AMATEUR SERVICE AGENCY BULLETIN NO. 1010

EQUIPMENT TYPE: Power Supply 516F-2

SUBJECT: A. Bias Diode Change and Capacitor Change
B. Bias Voltage Range Increase
C. Check Wiring of Fuse F1

A. Bias Diode and Capacitor Change

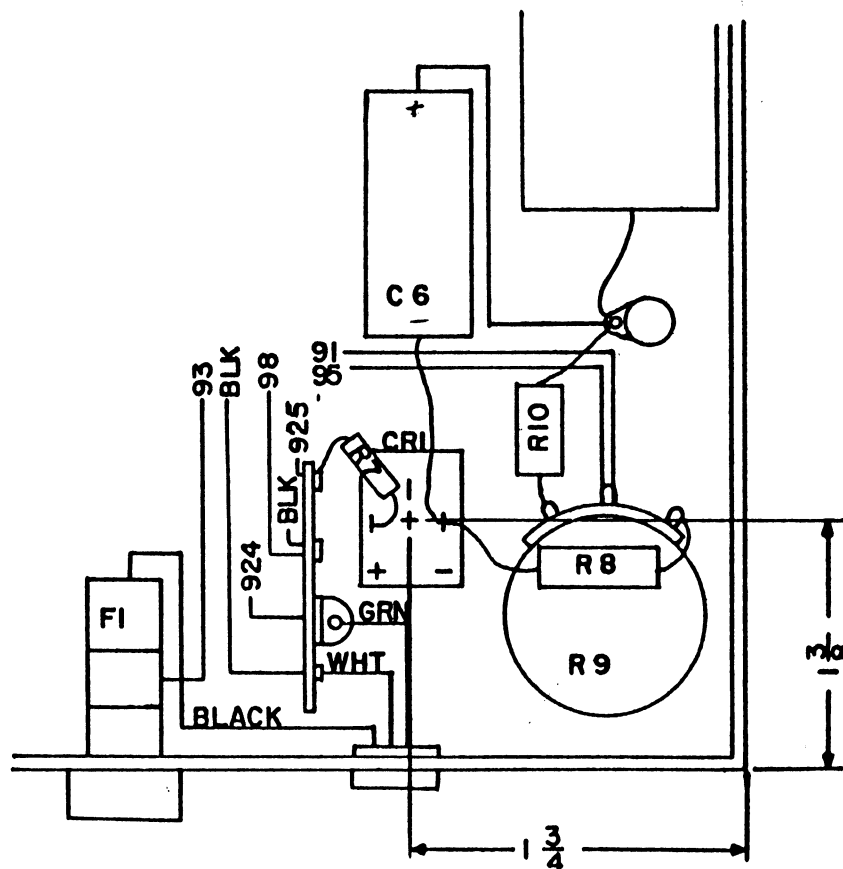
A high voltage transient in the bias line of some 516F-2's has been destroying the silicon diode (used in some models) which causes the filter capacitor to explode. If a failure occurs, the following modification is recommended (see sketch).

NOTE: In some cases a hole may have to be drilled in the chassis to facilitate mounting of the selenium diode.

In some cases the bias range of the 516F-2 may not be sufficient to give the desired idle current in a 32S or KWM-2. The following modification is then recommended. Make the changes of Part A with the following modification:

In some power supplies, the wires to the fuse holder XF1 were transposed. This makes the rim of the fuse hot with respect to ground. Check to see if the wires connected to fuse holder are in the same locations as shown in the sketch of Part A.

<u>ITEM</u>	<u>DESCRIPTION</u>	<u>PART NUMBER</u>
CR1	Rectifier, Metallic: Selenium	353-0153-00
R7	Resistor, Composition: 100 ohms \pm 10%, $\frac{1}{2}$ w	745-1310-00
R8	Resistor, Composition: 4700 ohms \pm 10%, 2w	745-5680-00
R9	Resistor, Variable, Wirewound: 2500 ohms \pm 10%, 2w	750-0522-00
R10	Resistor, Composition: 5600 ohms \pm 10%, 2w	745-5684-00
C6	Capacitor, Electrolytic: 10uf, -15% + 50%, 250v DCW	183-1046-00

<u>CHANGE</u>	<u>TO</u>	<u>PART NUMBER</u>
R8, 4700 ohms, 2w	R8, 3300 ohms, 2w	745-5673-00
R9, 2500 ohms, 2w pot	R9, 5000 ohms, 2w pot	376-2376-00
